RELOCATION OF SAWMILL OPERATIONS
MICHIGAN DEPARTMENT OF CORRECTIONS
MICHIGAN STATE INDUSTRIES
IRON RIVER, MICHIGAN

PROJECT NO: 94-263

You are hereby requested to execute promptly this Bulletin which interprets the Contract Documents or orders changes in the Work. Please submit no limited quotation for changes in the contract sum and/or time included to proposed modifications to the Contract Documents described herein.

DESCRIPTION:
Proposed Modifications:

SAWMILL ELECTRICAL PLAN

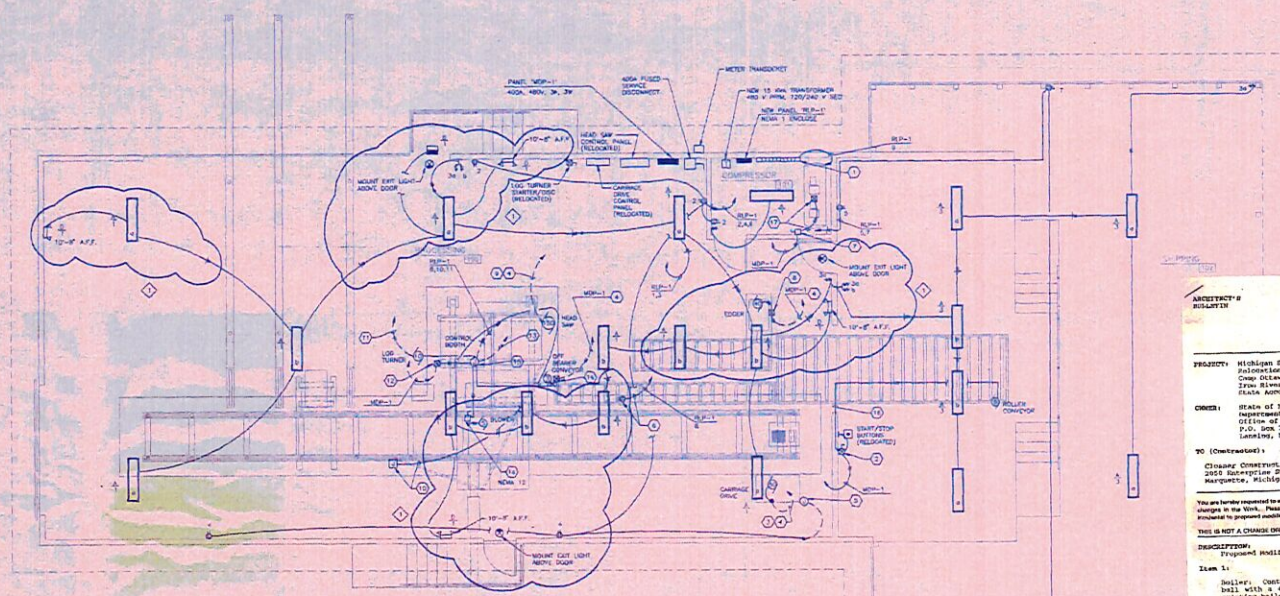
Sheets E2.0 & E3.0:
Contractor shall provide and install (5) exit and (8) emergency lights in locations shown on revised drawings E2.0 & E3.0. Circuit emergency lights as shown. Exit light shall be Lumalexit model D-100-R10, self-luminous exit sign, as approved, or equal. Emergency light shall be Sure-Lites model IMM-1-RS-7, sealed lead calcium battery, with wire guard, or equal. Mount at heights indicated on revised drawings E2.0 and E3.0.
